THE COMMONS AT FALCON FIELD FILING NO. 1

CONSTRUCTION PLANS

ISSUE	DATE
INITIAL ISSUE	12/16/24
RESUBMITTAL	08/17/26
DESIGNED BY:	KGV
DRAWN BY:	CGH
CHECKED BY:	TDM
FILE NAME:	CV&NOTES
PREPARED UNDER MY DIRECT SUPERVISION FOR AND ON BEHALF OF DREXEL, BARRELL & CO.	
DRAWING SCALE: HORIZONTAL: N/A VERTICAL: N/A	
COVER SHEET	
PROJECT NO. 21604--00CSCV	
DRAWING NO.	
C1	
SHEET: 1 OF 31

EL PASO COUNTY FILE # SF2435

**E. WOODMEN RD
TURN LANE
EXTENSION**

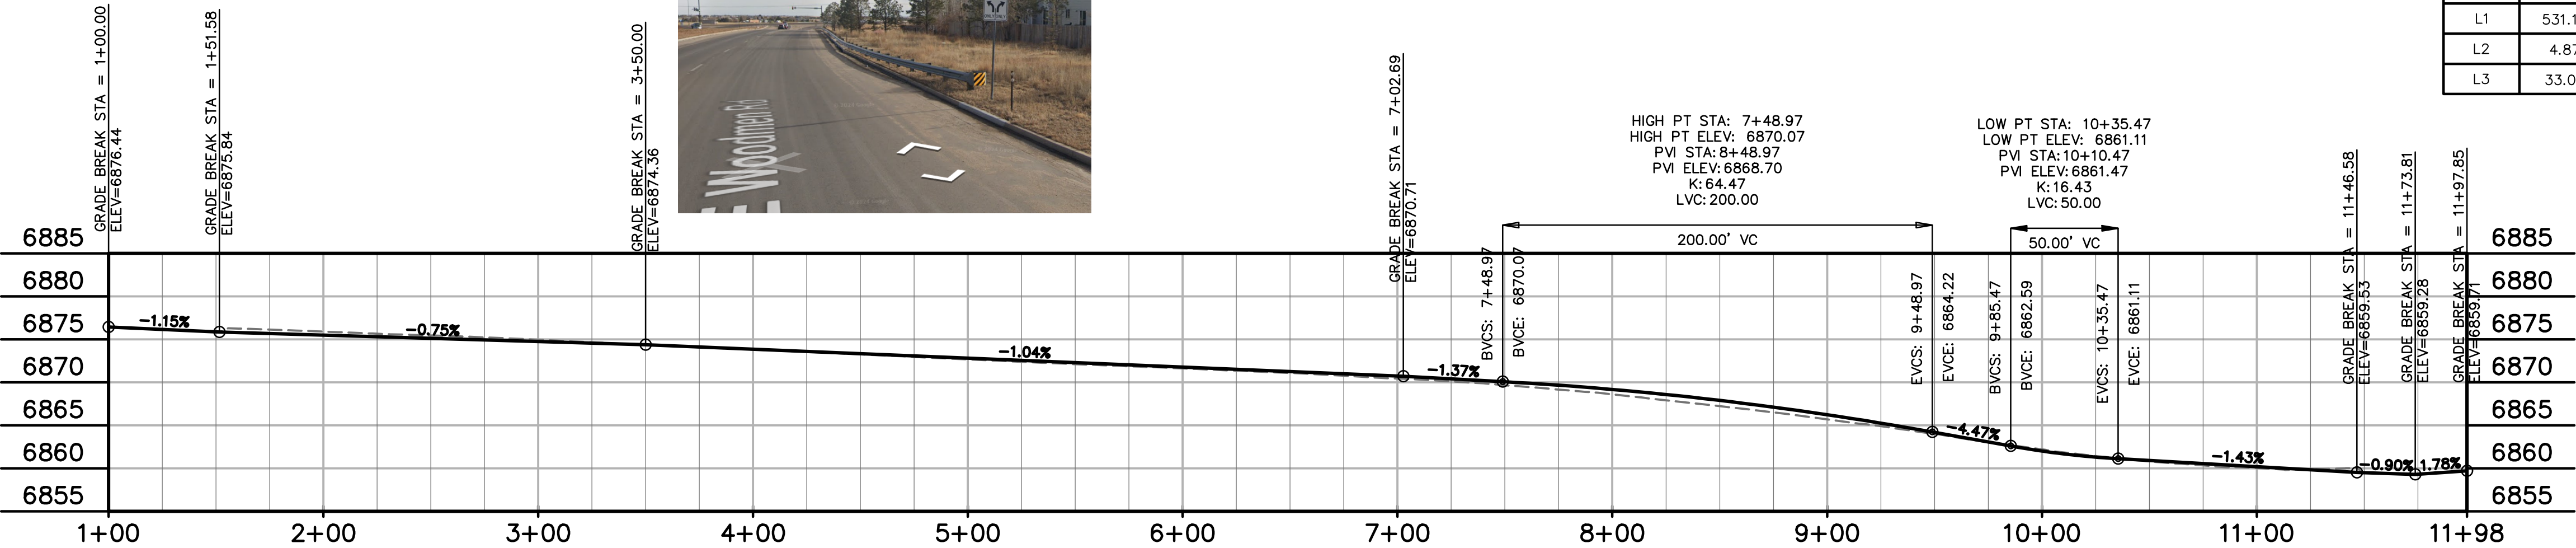
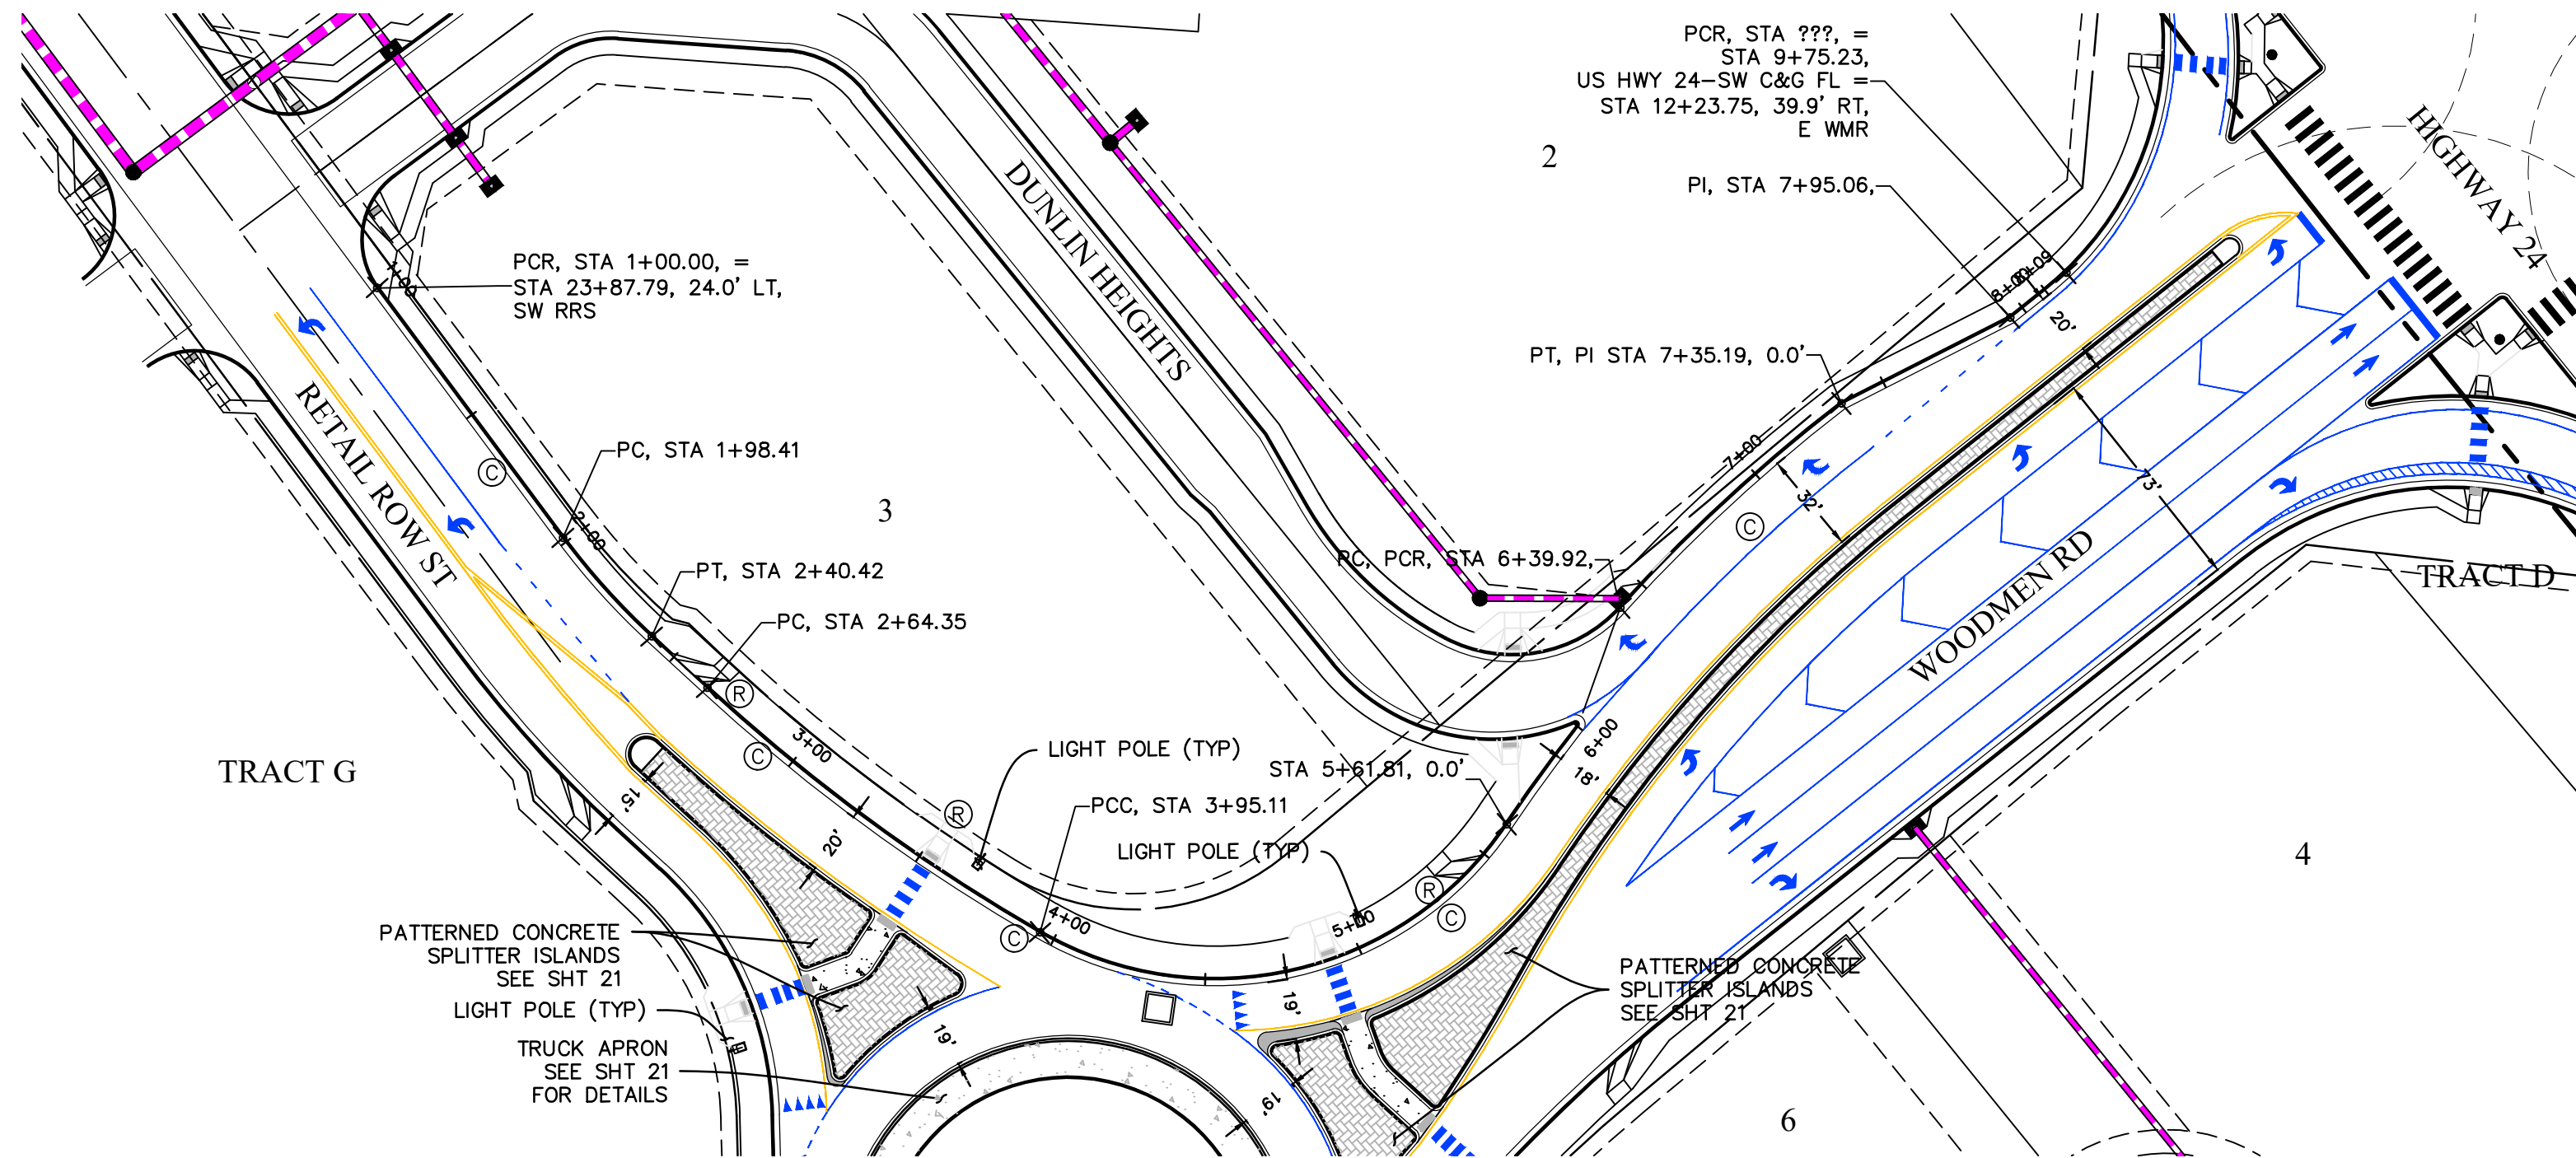
Previous comment:
identify the distance
between arrows per
CDOT S-627-1
Review 5: unresolved.

provide updated and/or additional signage
due to the new intersection traffic control.
For example the current R3-8 signage would
need to change due to the new through
movement.

label and provide
specs for the
proposed chevron
stripping.

SOUTH OUTFALL AND CHANNEL
1"=20'

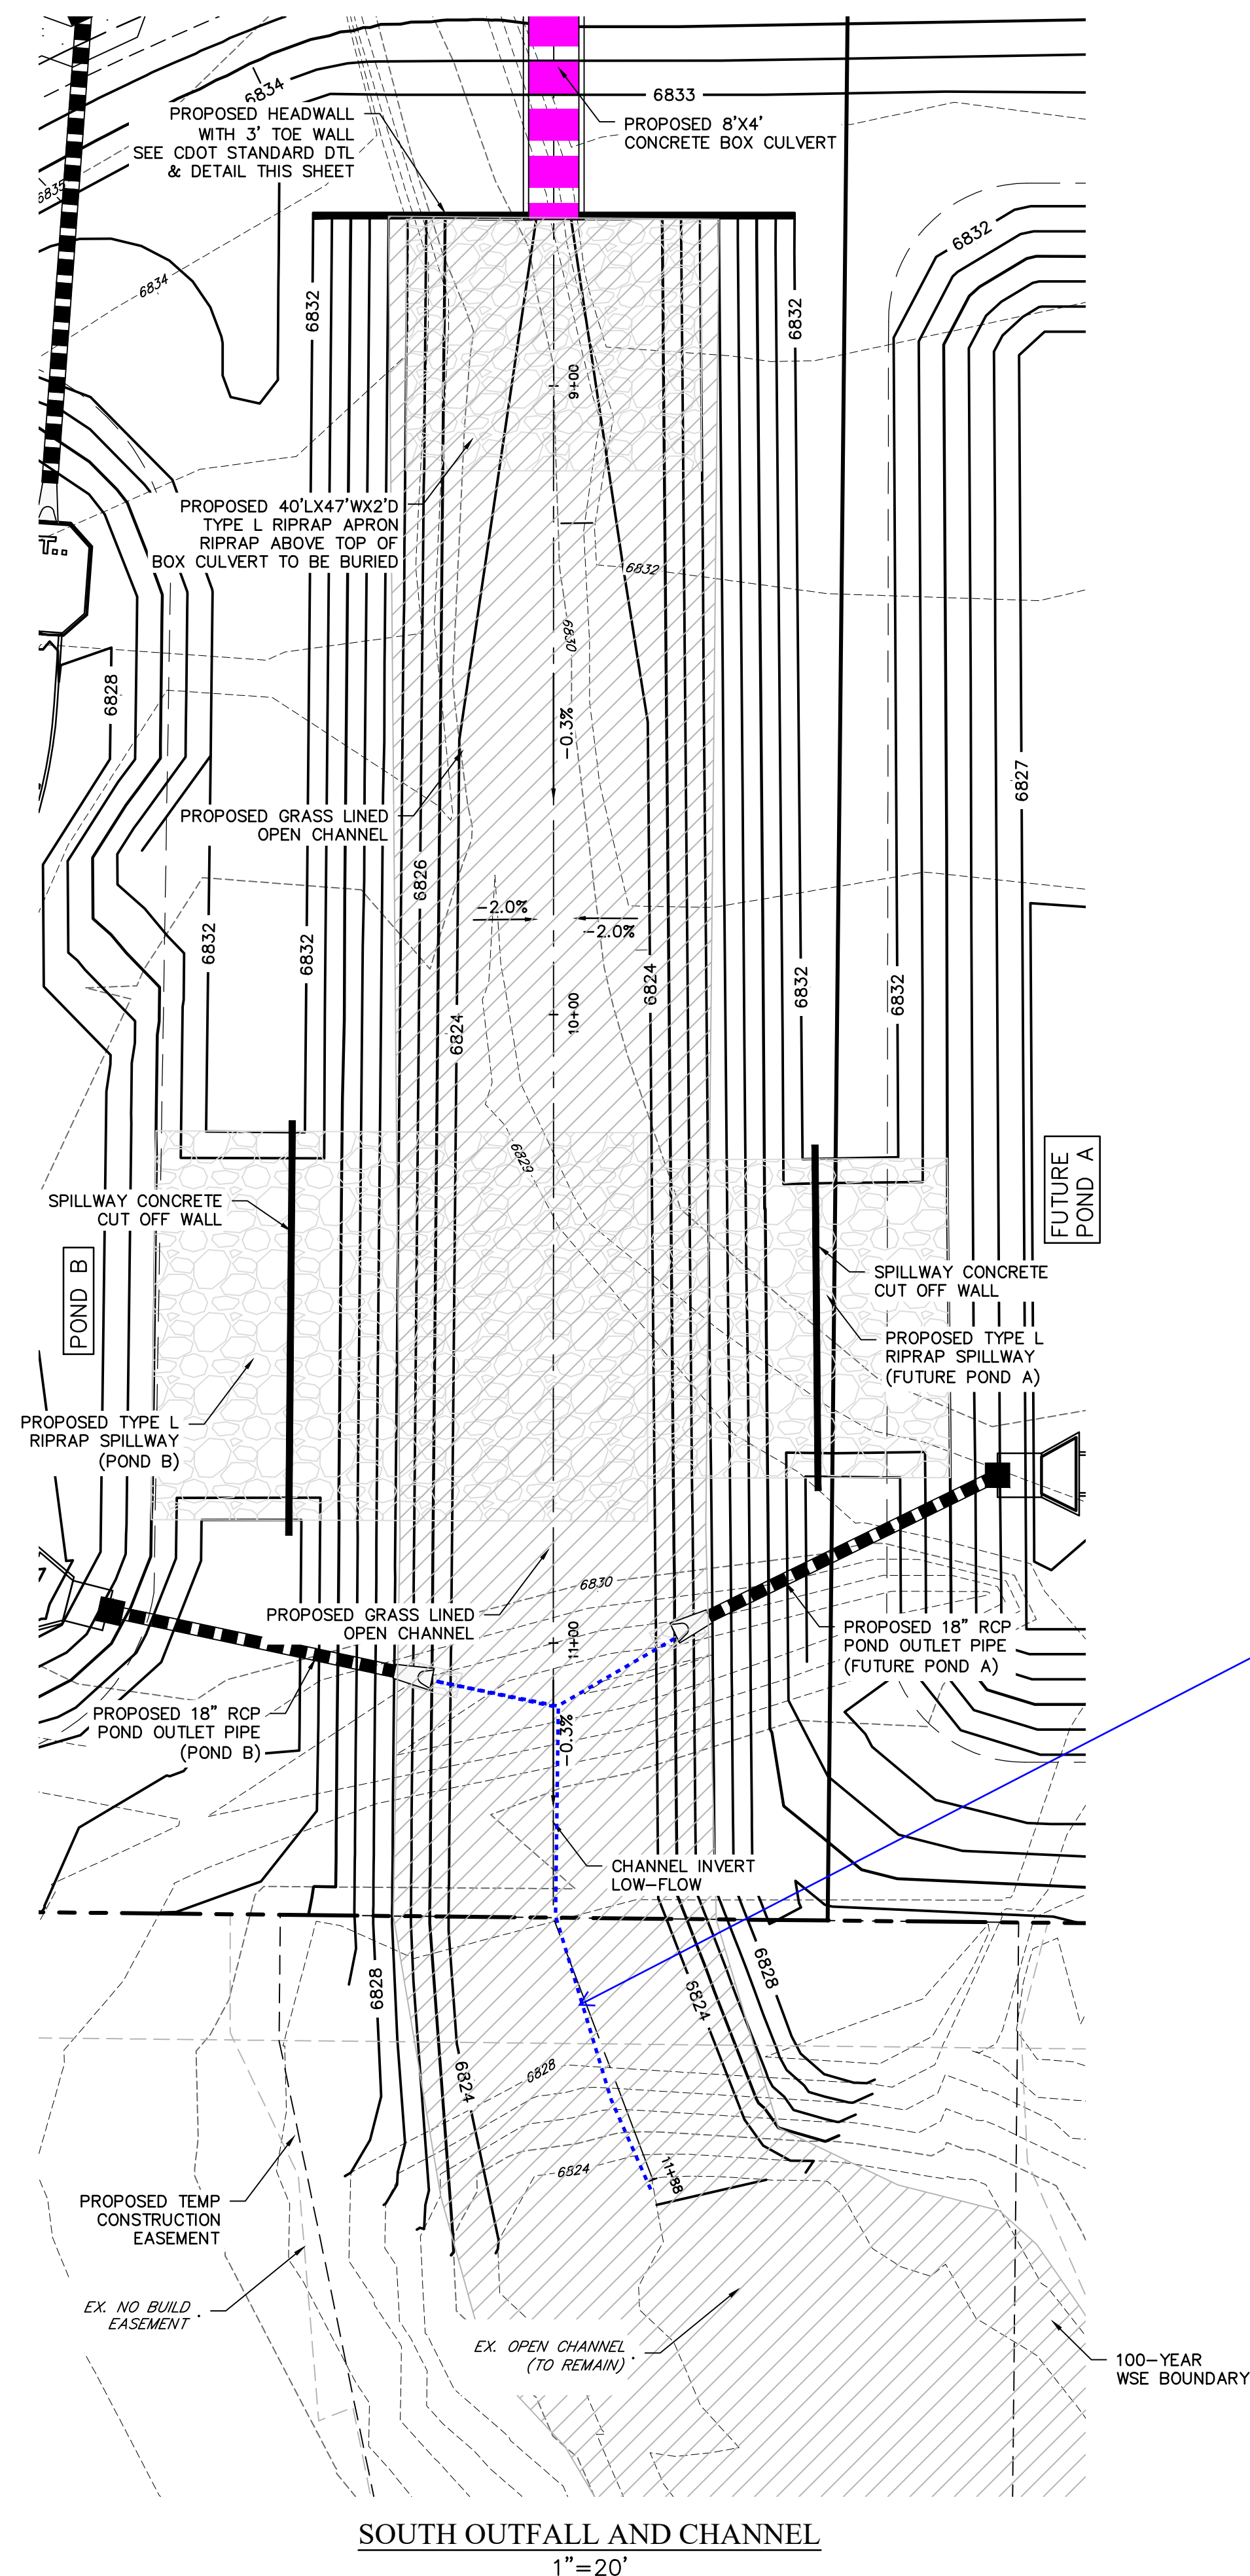
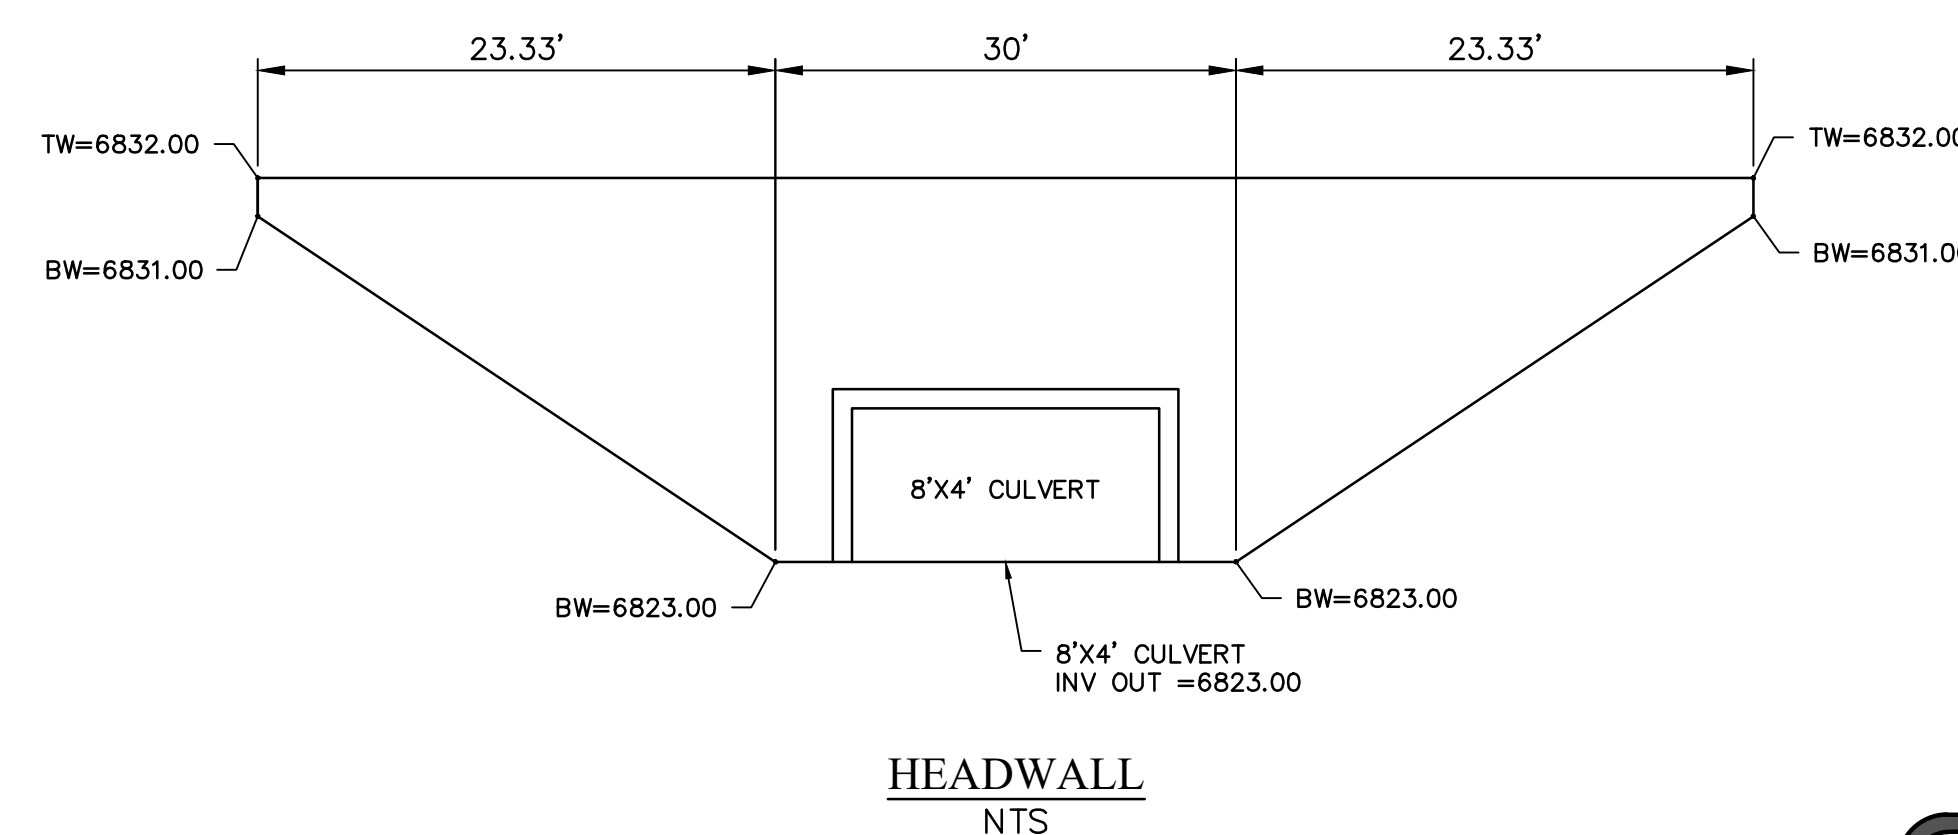
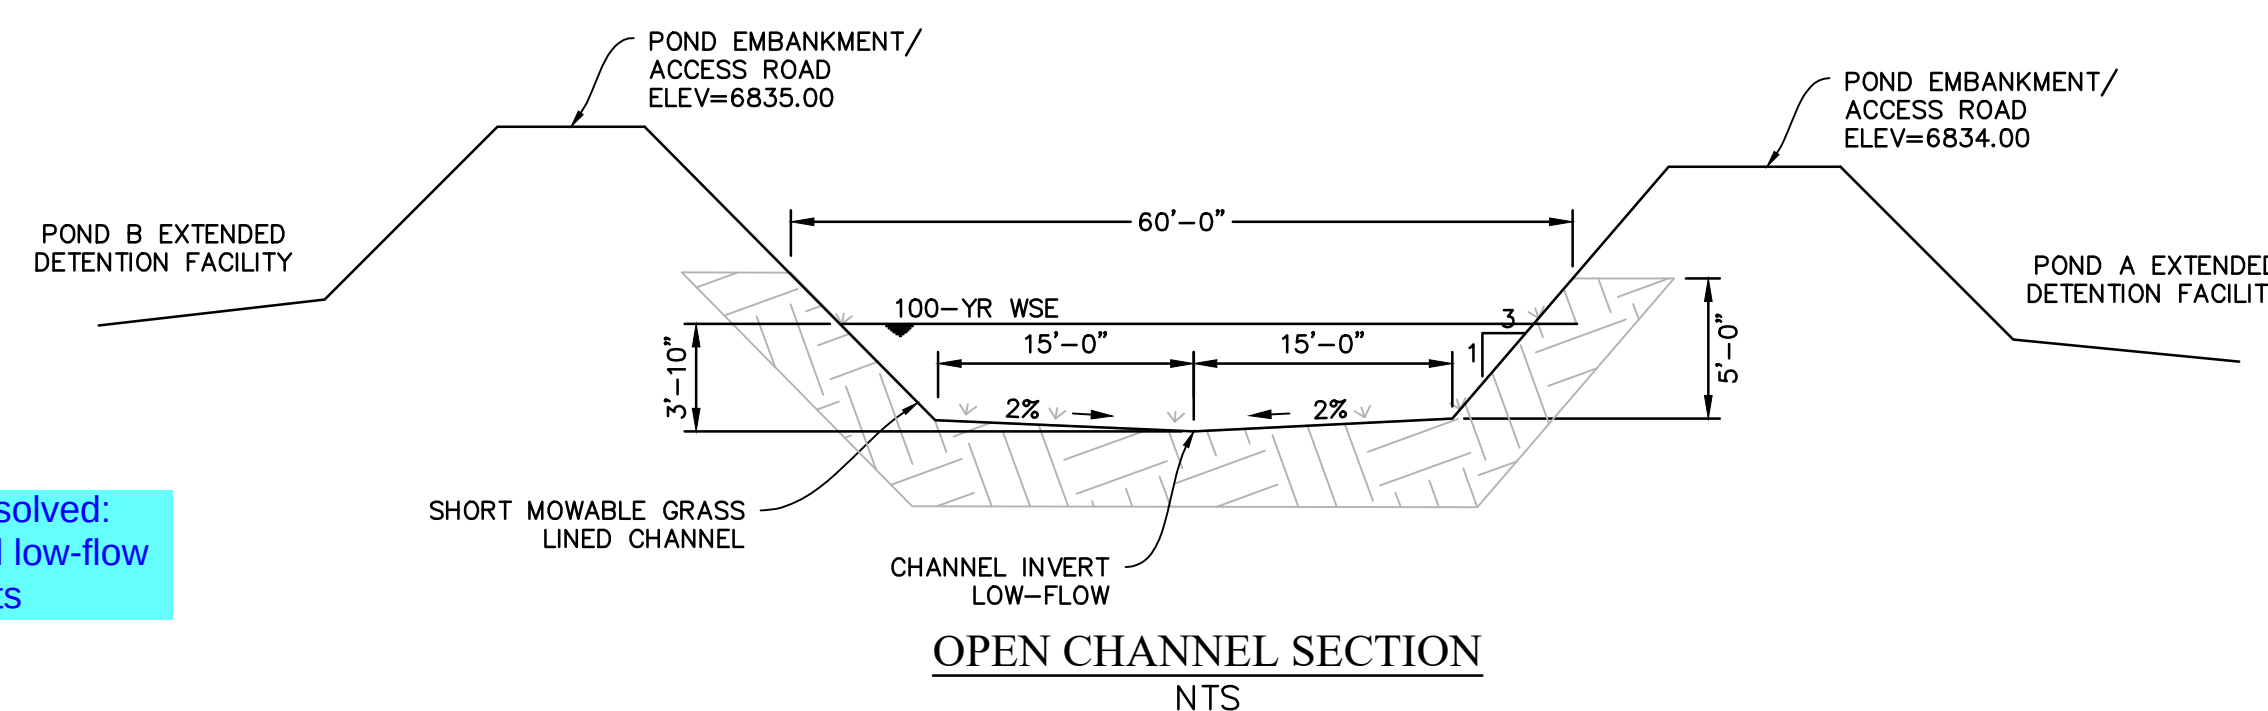
Unresolved:
Label low-flow
inverts
